## ADDENDUM #1

November 17, 2021

This Addendum to the Bid Documents is issued to clarify, correct, and supplement the Drawings issued as "WOODBURN MUSEUM/THEATER RENOVATION PERMIT REVISION DRAWINGS" dated September 27, 2021. This addendum adds to, and where in conflict with, supersedes previously issued drawings and addenda. This Document is hereby made a part of the Contract Documents to the same extent as though it were originally included therein.

Woodburn Museum / Theater  
Renovation

Scale As indicated  
Date 11/16/2021  
Sheet No. **A101**

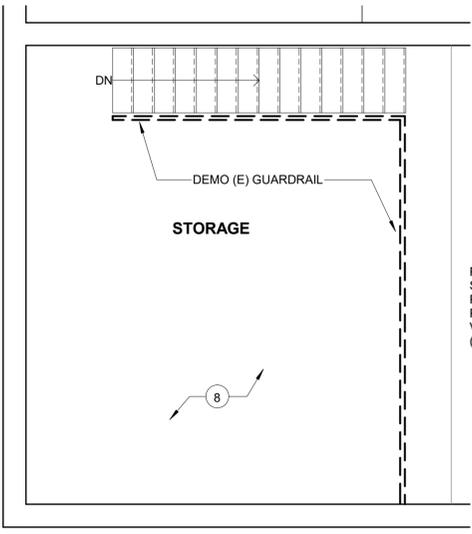
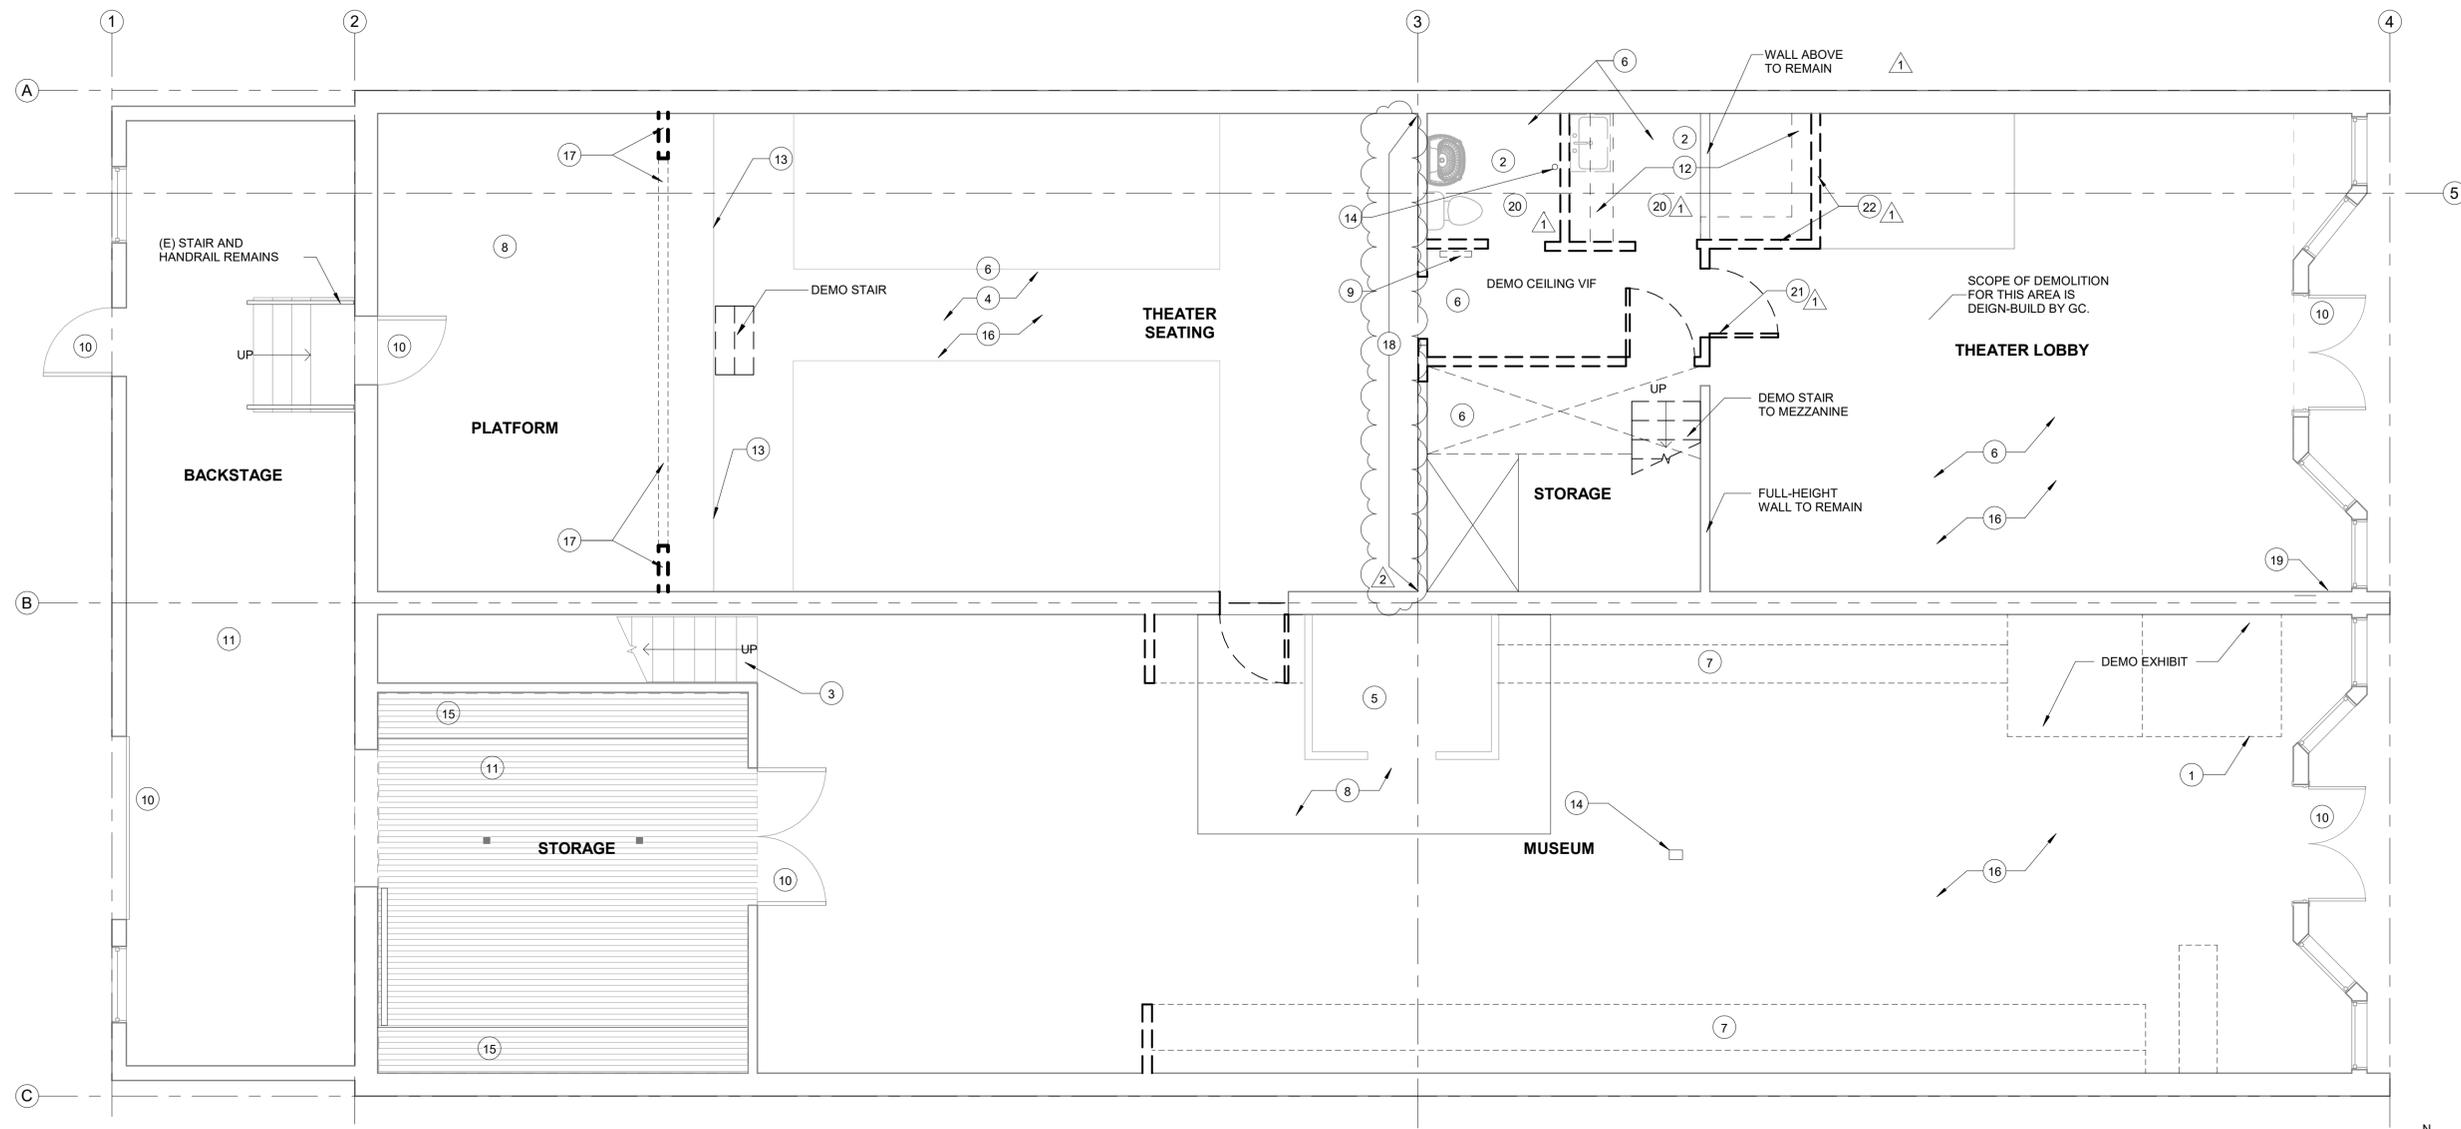
- 1.A101.1 Theater 116, East Wall: Wall is in poor condition; plan to remove all existing gypsum board/plaster; remove window trim. New work will include providing one (1) window from storage 115 to Theater 116; raising height of door to 80"; install thick insulation at bathroom wall; new gyp finished smooth and painted; lighting controls located adjacent to door. New elevation provided on A501.

Scale As indicated  
Date 11/16/2021  
Sheet No. **A102**

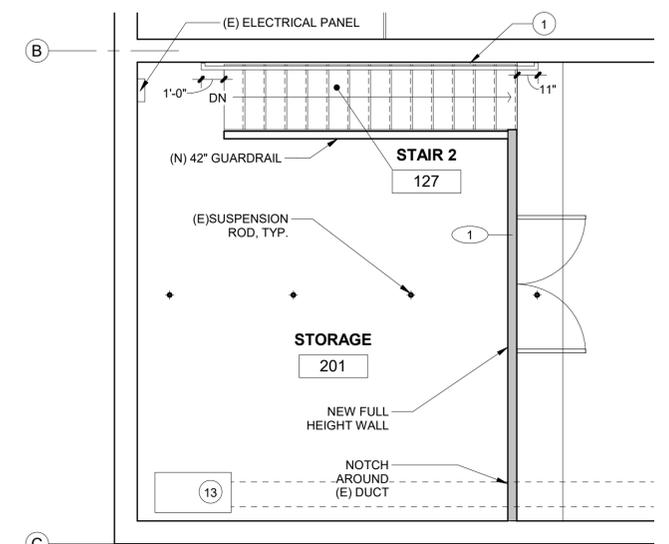
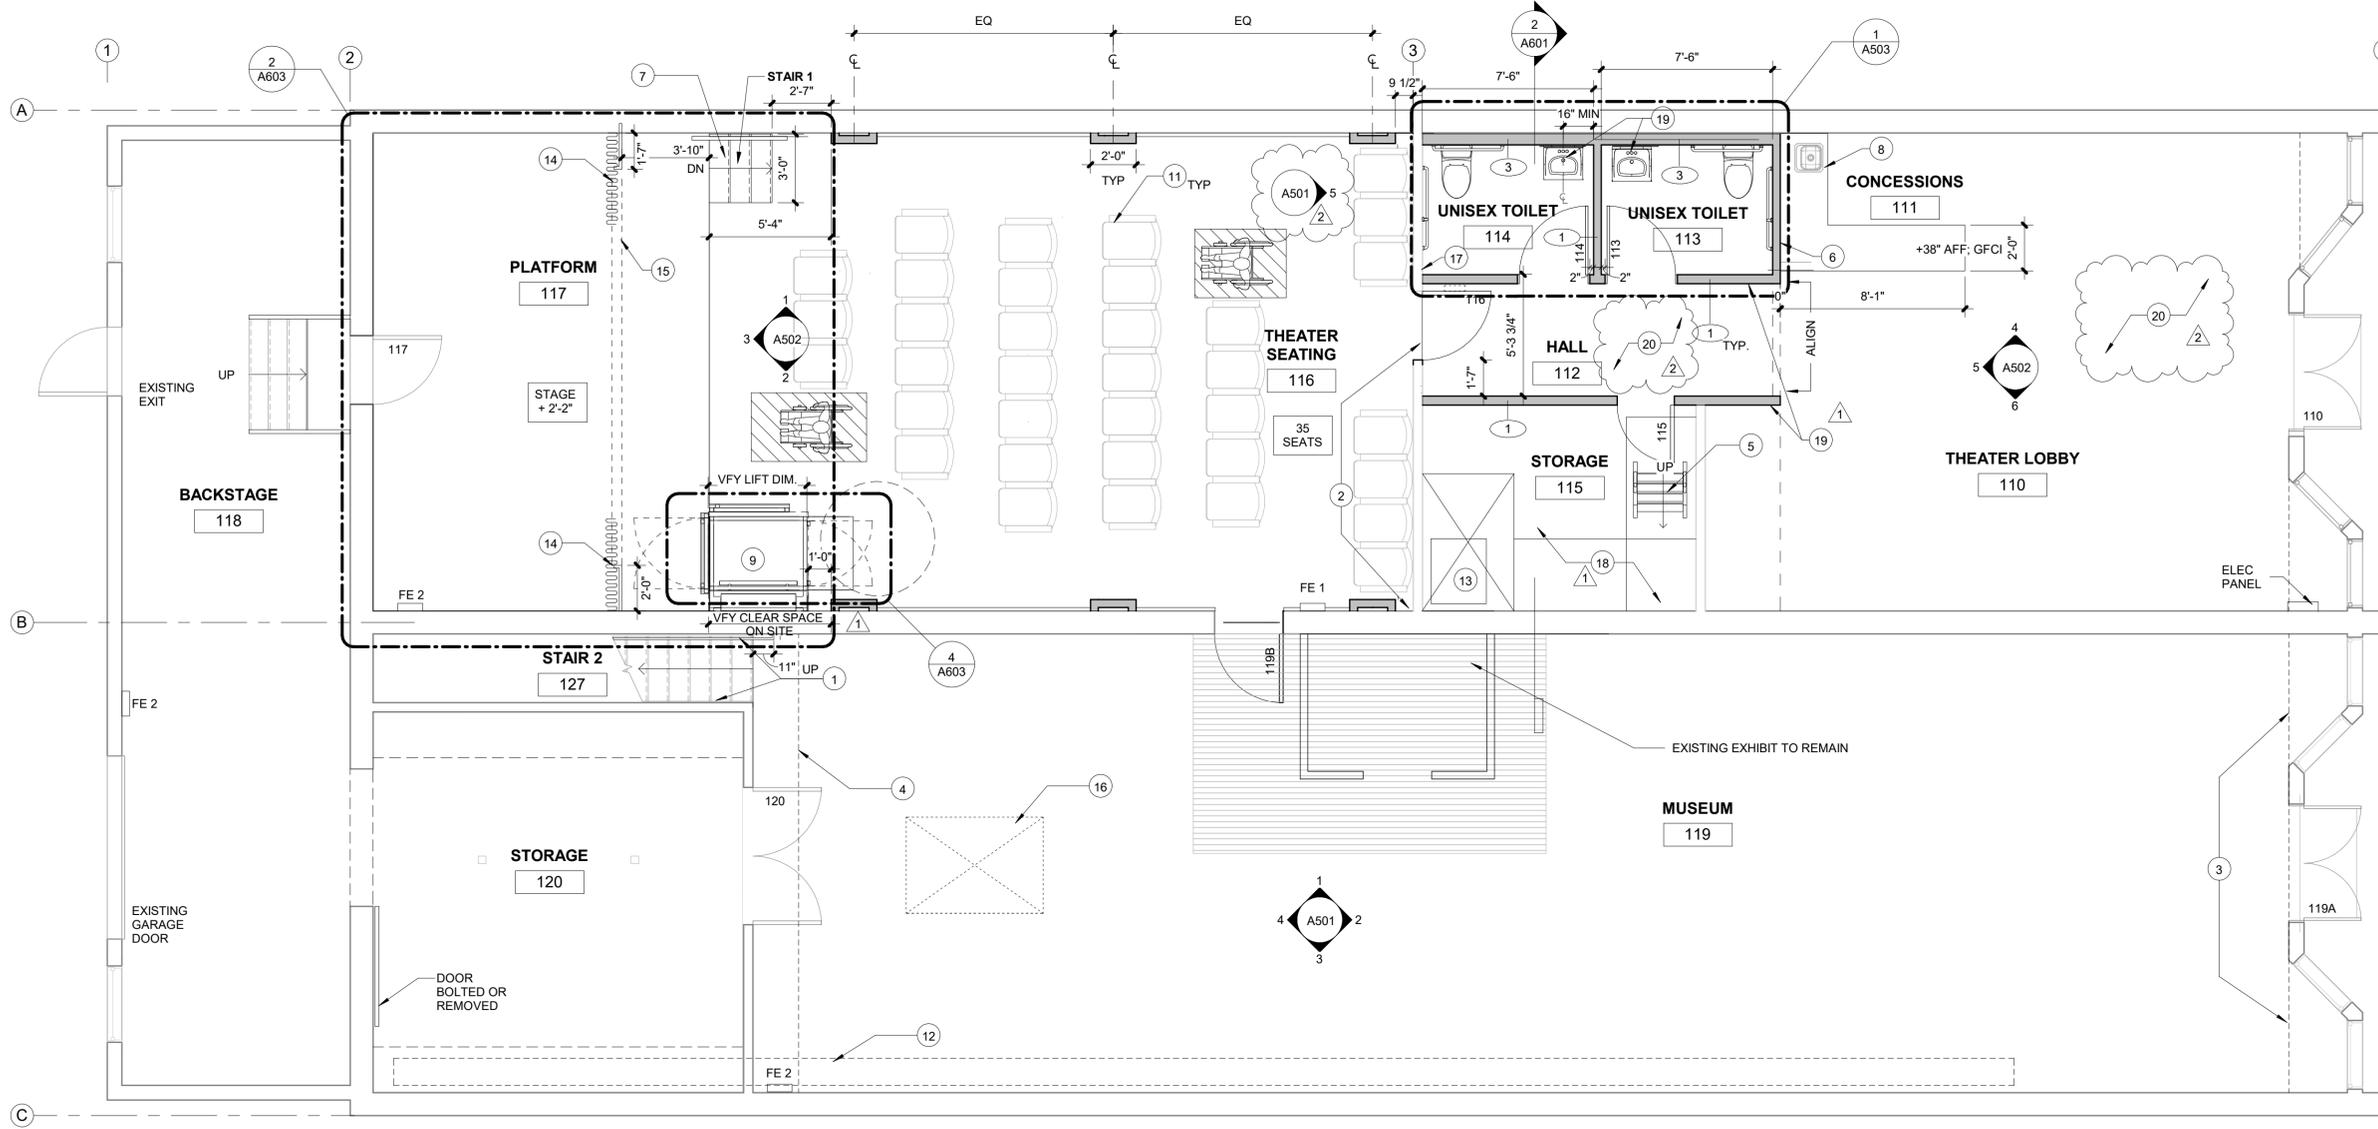
- 1.A102.1 Lift at Theater Platform: Revised the location of the proscenium to match existing location; 53" west from the front of stage. The stage needs to be extended 8" to the east to provide a full 60" landing for the lift per code. Contractors should plan to build this platform out to accommodate the required clear space. Face of new stage extension walls to be painted wood. Provide low voltage connection for phone associated with lift. See change to Keynote 9, lift is now **OFOI** with GC providing power and stage extension to accommodate lift.

- 1.A102.1 Asbestos Abatement in the Lobby 110, adjoining hallway 112, and 113, 114 and 115 has resulted in damaged joists. Added Keynote 20 to address replacing broken/damaged joists and providing a substrate for the scheduled flooring.

- 9 VERTICAL PLATFORM WHEELCHAIR LIFT FOR STAGE OFOI. SEE SPECIFICATION A701. PROVIDE POWER AS REQUIRED; OWNER'S VENDOR TO INSTALL PER MANUFACTURER'S INSTRUCTION WITH LAG SCREWS ATTACHING UNIT TO FLOOR.

- 20 (E) FLOORING WAS REMOVED DURING ACM ABATEMENT. JOISTS ARE IN POOR CONDITION; PLAN TO REPLACE 250 SQ FT OF JOISTS. PROVIDE NEW PLYWOOD SUBSTRATE IN 110; 112, 115, 114, 115.

Scale As indicated  
 Date 11/16/2021  
 Sheet No. **A201**

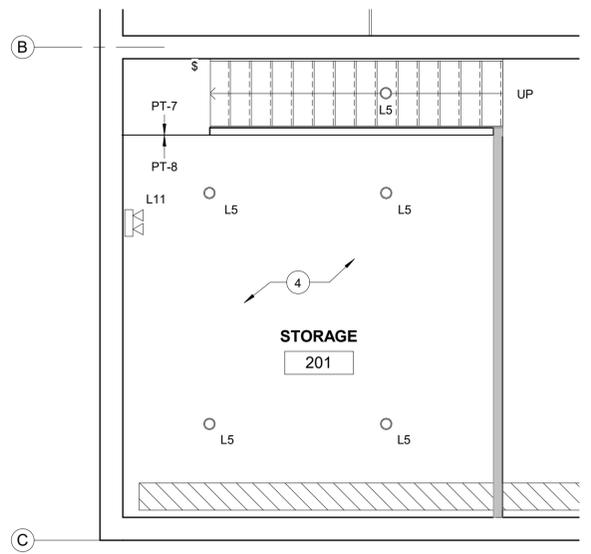
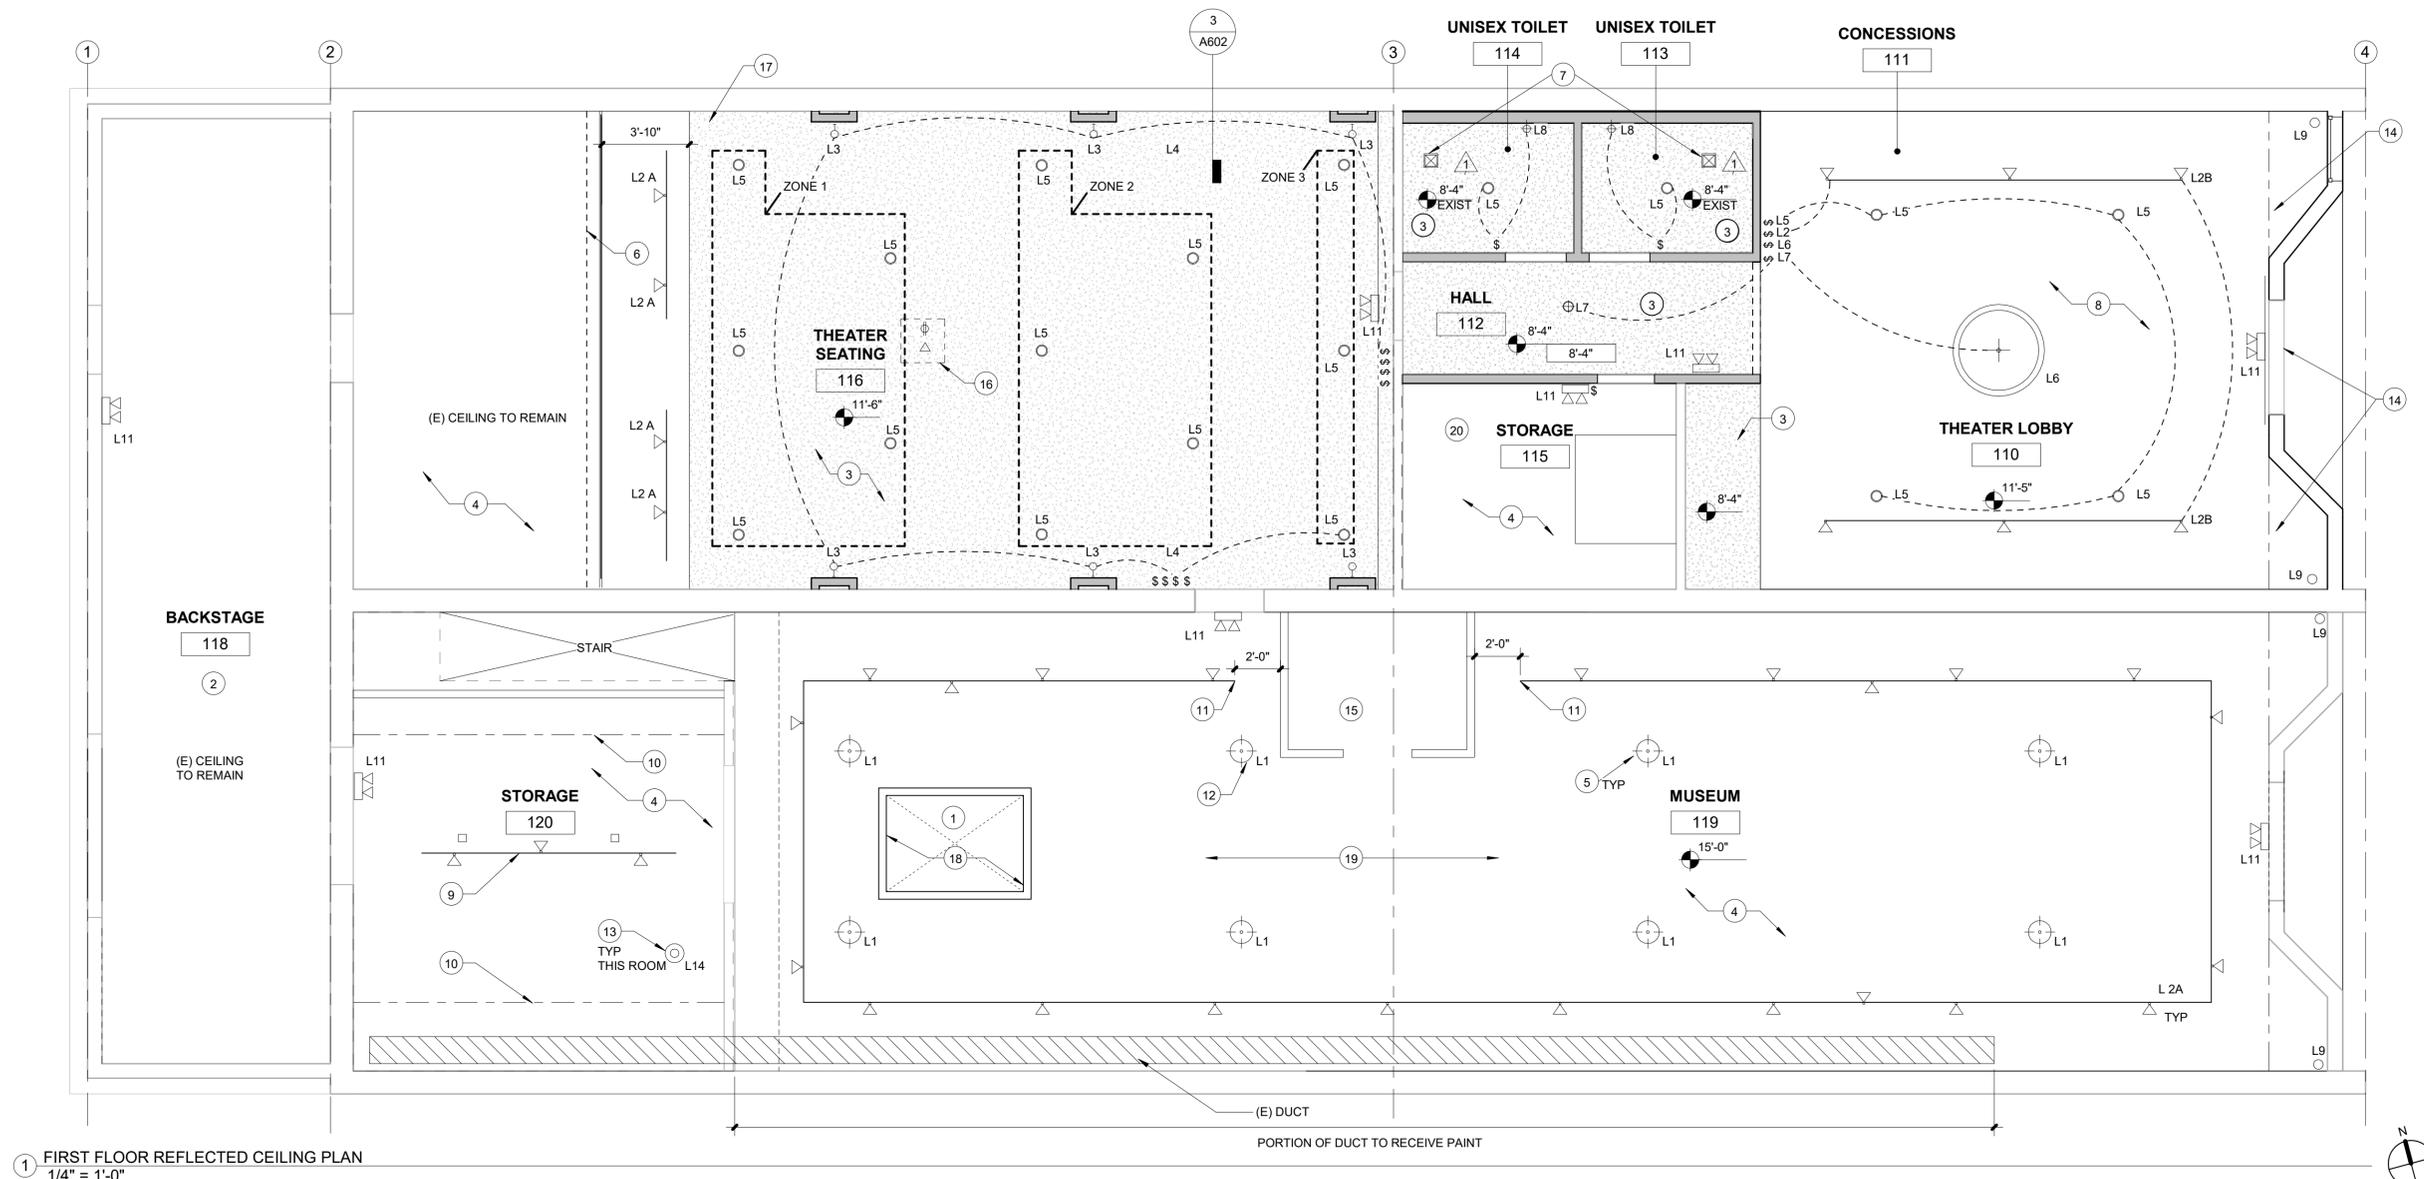
- 1.A201.1 Keynote 3 as it pertains to Theater 116 only: Due to asbestos abatement in this room, this existing ceiling material needs to be demolished and new gypsum board installed, attached to existing joists and finish; provide lighting as originally shown. Existing plenum space above theater is approximately 5'-0" and accessible.

- 1.A201.2 Keynote 17 corrected to read L12 fixture, not L14 as noted in the original bid documents.
- 1.A501.1 Added an elevation of the East wall, Theater 116.

- 2 OPEN TO UNDERSIDE OF STRUCTURE. NO WORK HERE; NO CHANGE TO LIGHTING.
- 3 NEW GYP BOARD CEILING. REMOVE ALL (E) PLASTER / GYP MATERIAL AND REPLACE WITH NEW; FINISH TO LEVEL 4 FINISH.

- 16 APPROX. LOCATION OF PROJECTION OFOI; PROVIDE POWER IN CEILING AS REQUIRED FOR EQUIPMENT; PROVIDE DATA/ LOW VOLTAGE CONNECTION
- 17 PROVIDE (1) LIGHT L-12 AT STEPS. ON FACE OF MIDDLE RISER.

2 ENLARGED FLOOR PLAN - STAGE  
1/2" = 1'-0"

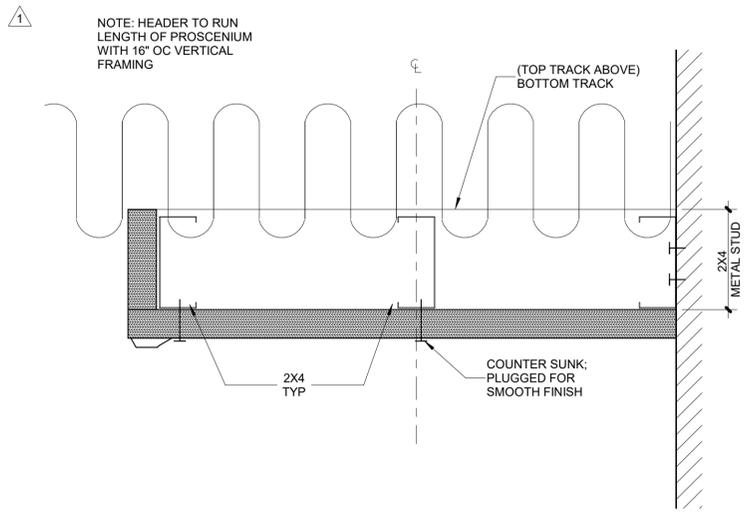
- 1.A603.1 2/A603 shows stage extension to accommodate clearances required for the lift.
- 1.A700.1 Theater Lobby 110: wall finishes – all walls should be skim coated to a smooth finish prior to paint. This will be added as a keynote and should be included in pricing.
